UNITED STATES PATENT AND TRADEMARK OFFICE

Office Action Summary

This is the first Office Action for application number 10/777,464 Reinforced Rod Holder, filed on 2/11/04. Claims 1-18 are pending.

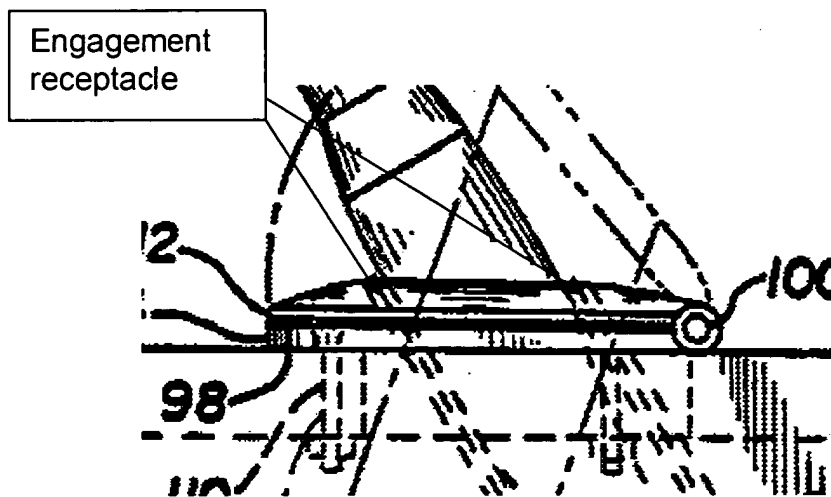
Potter, Jr. teaches a rod holder (10) which has an upper flange (12, 14) and a receiving socket (30) which teaches a liner (35) which extends from the upper flange

into the receiving socket, used to cushion the fishing rod handle during use, to prevent damage to the handle of the rod. Potter also teaches that the upper flange has an engagement receptacle (See Drawing Below), used for frictionally engaging the outer edge of the liner within the flange. Therefore, it would have been obvious to one having ordinary skill in the art at the time the invention was made from the teachings of Potter, Jr. to have added a liner in order to prevent damage to the fishing rod, during use, and to have added an engagement receptacle in the upper flange in order to frictionally engage the outer edge of liner to the device.
